**25 Old Gloucester Street,
London WC1N 3AF**

**Basement Impact Assessment
Audit**

For
London Borough of Camden

Project No.
14006-51

Part Plan of Basement Area showing adjoining
properties basements.

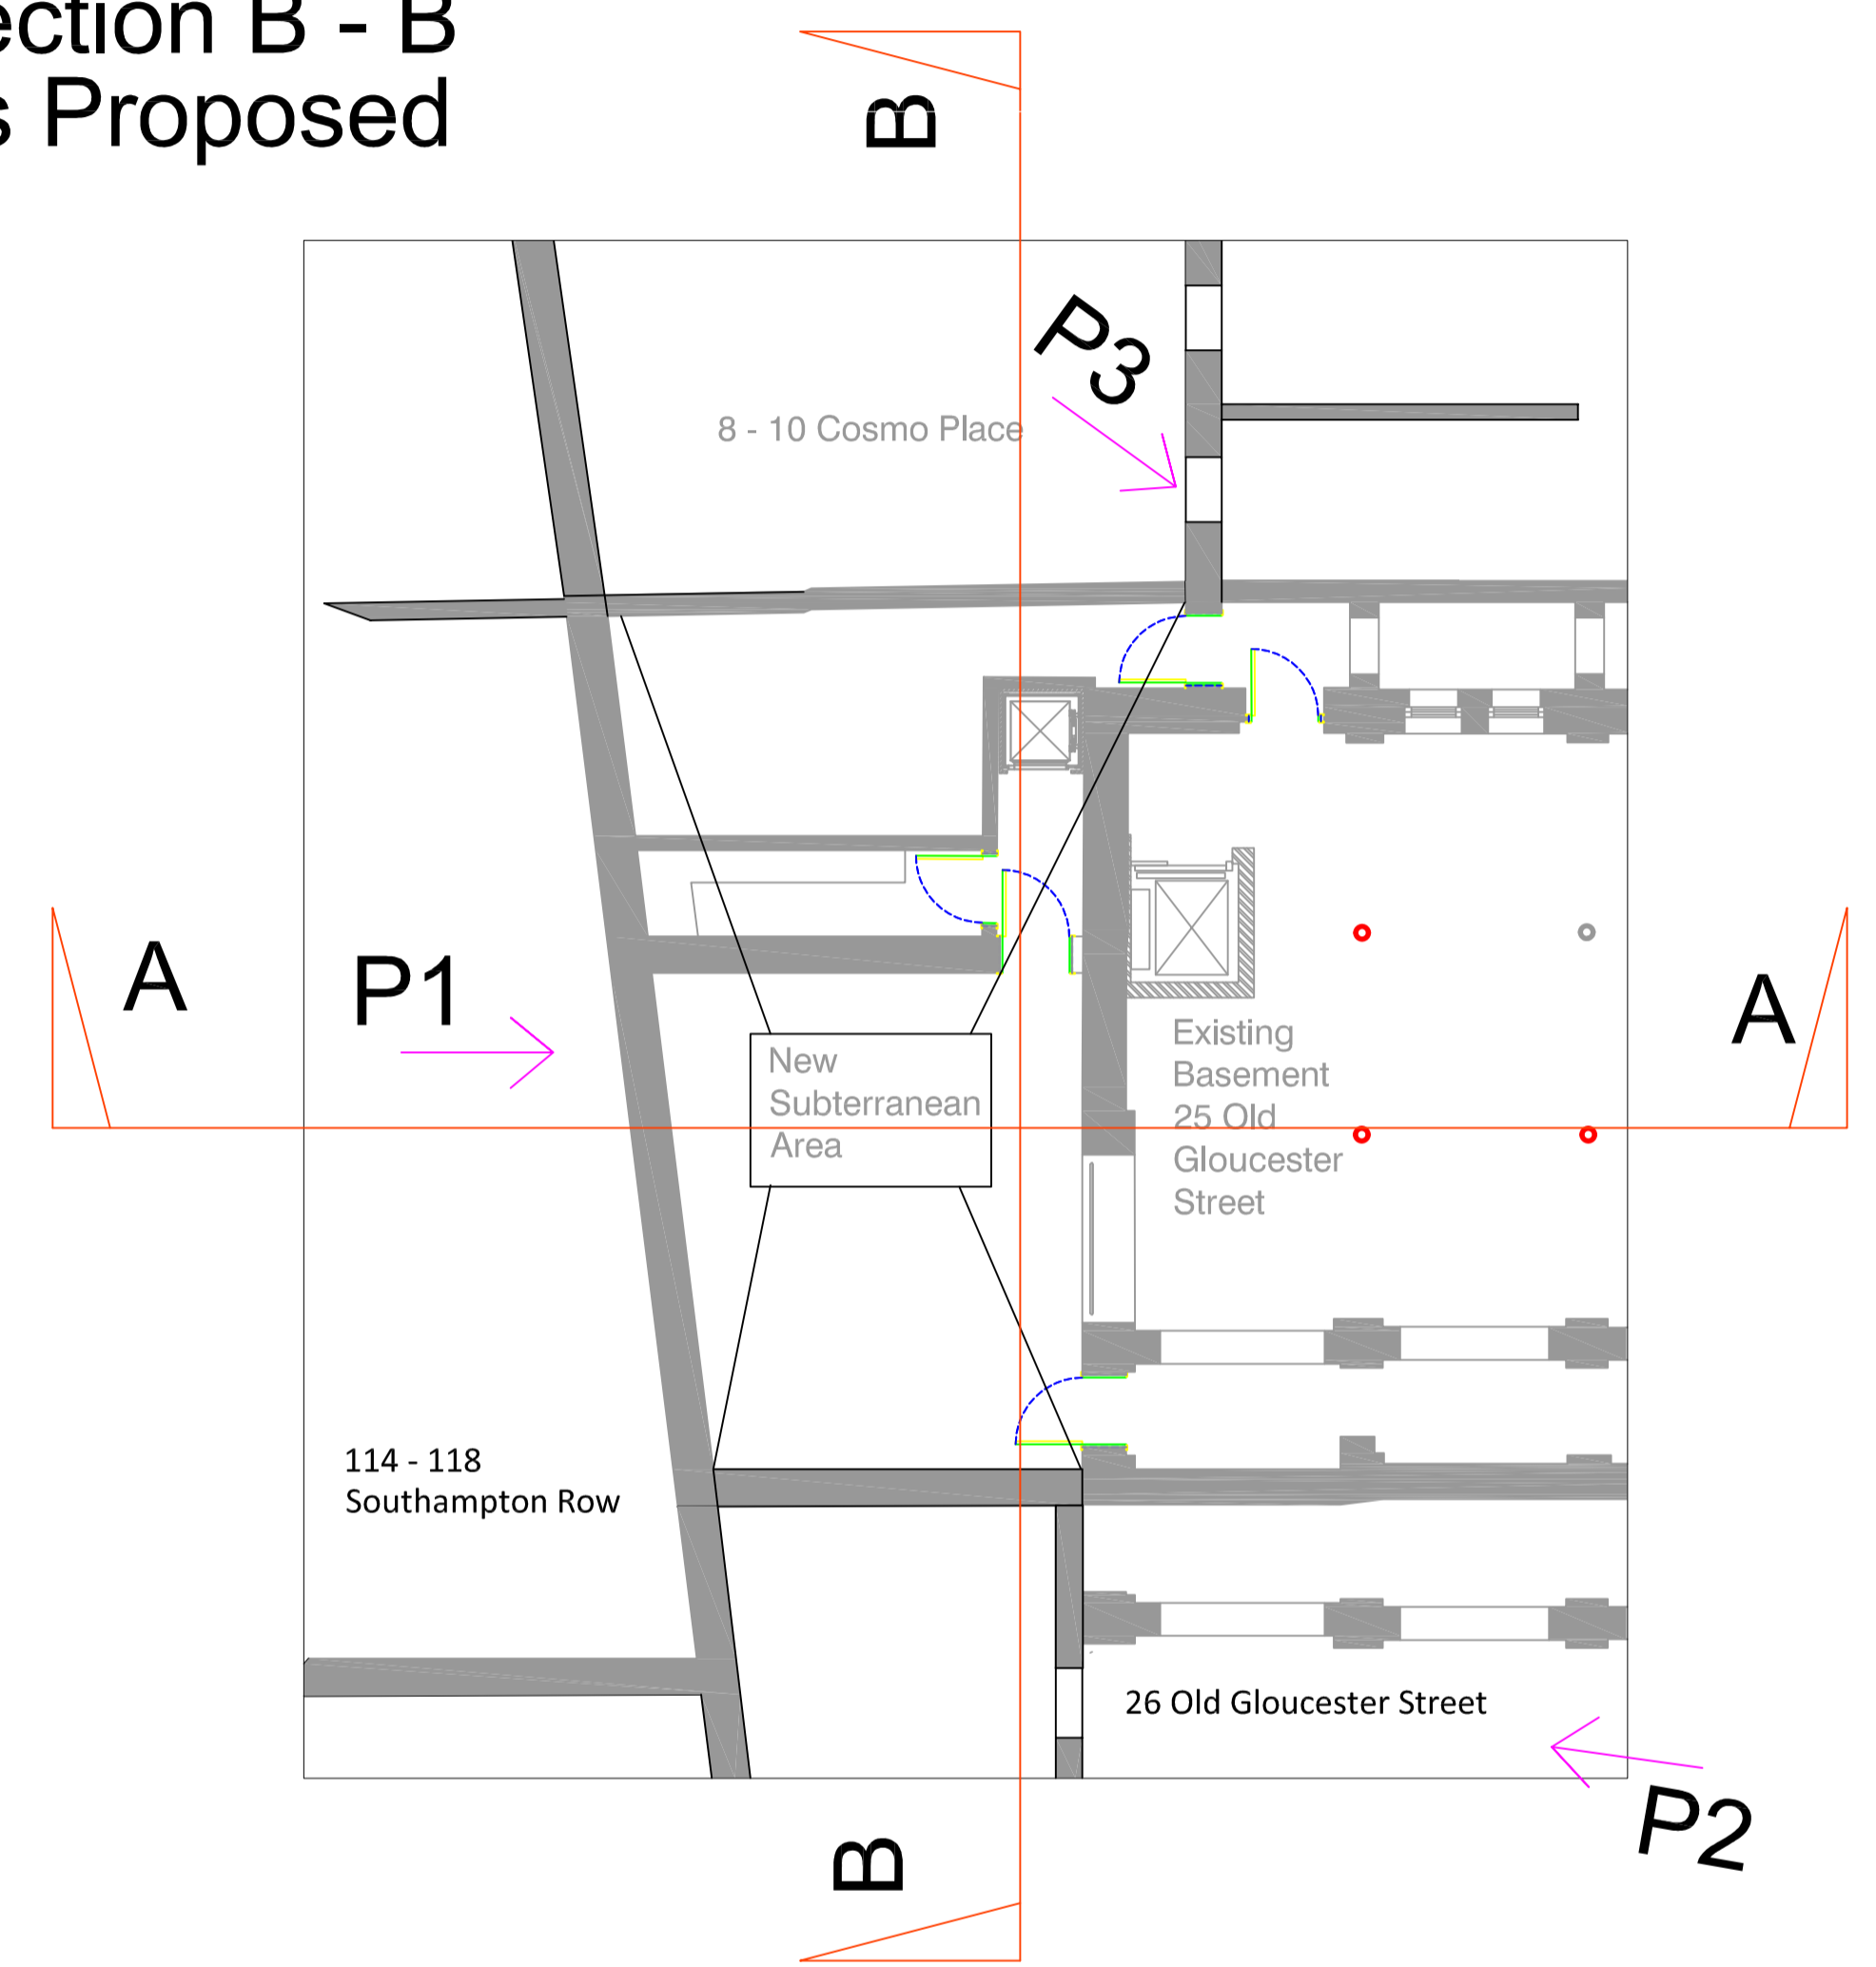
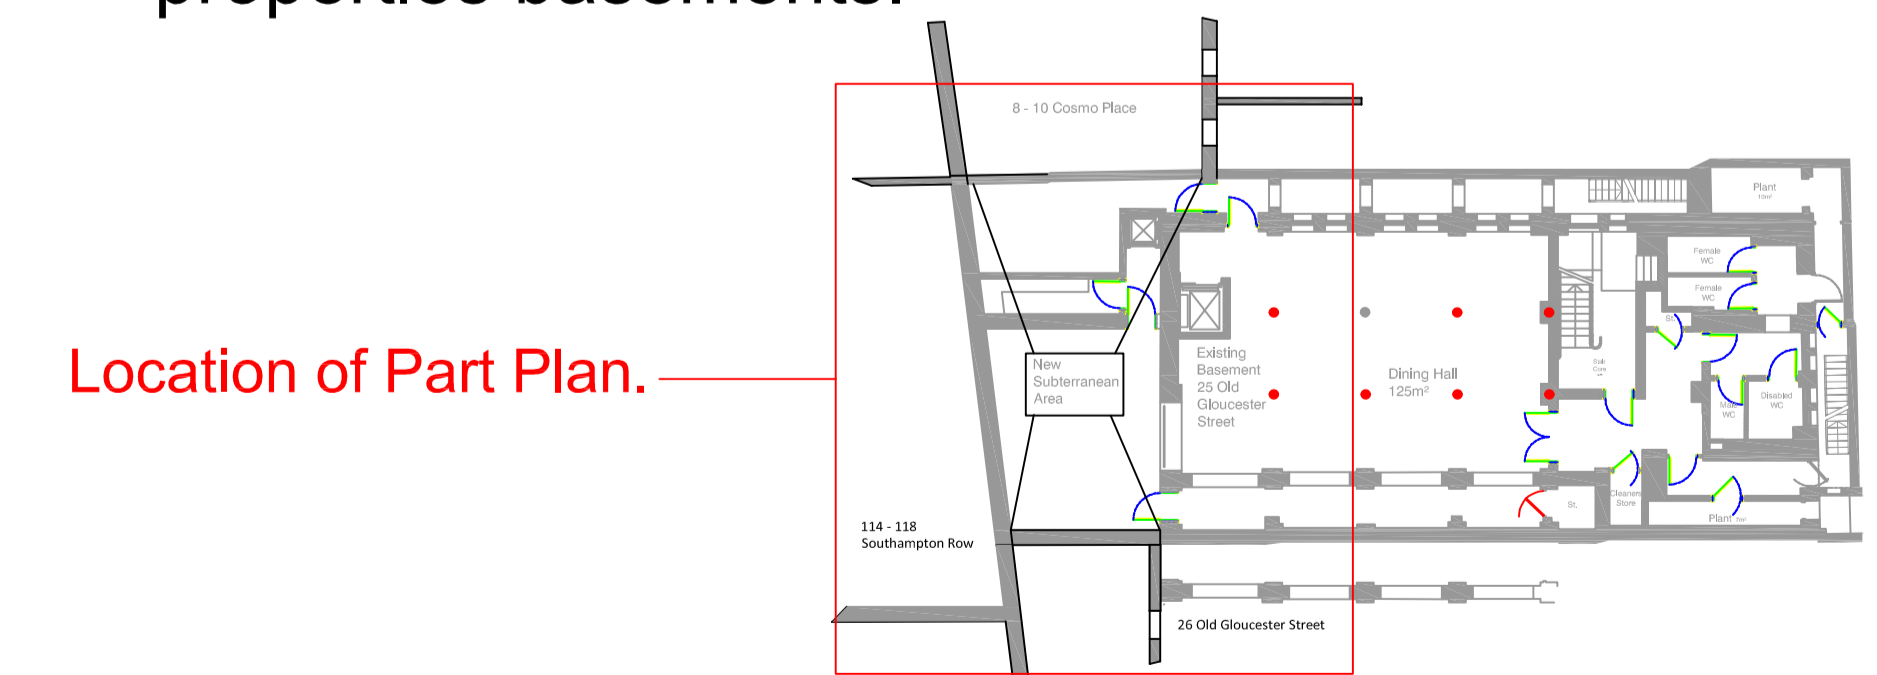
Following an inspection on the 25th January 2024 we can confirm all the properties around the proposed excavation have basements to a similar depth as the proposal. To this extent the proposal put forward for planning consent will only see the ground between the other basements being removed. To this extent I do not consider this action as the formation of a basement in the true sense of the word but more a unifying of all the subterranean areas within the locality of the proposal.

To demonstrate the above, we have prepared the attached drawing 23056-014 which includes photographs from within the adjoining basements and sections showing no temporary works will be necessary nor the formation of any retaining structures will be necessary. I would therefore propose that a Basement Impact assessment is no longer required for the scheme.

- 4.5 Following the D1 issue of the BIA Audit report, additional documents comprising a letter and drawing were provided to confirm that all the properties neighbouring the proposed development have existing basements that extend to a depth comparable to the proposed extension. As such, it has been confirmed that no underpinning will be required. The additional documents submitted are included in Appendix 3 of this report.

The basement will not significantly increase the depth relative to the neighbouring properties and as we see the situation now there will be no requirement for underpinning.
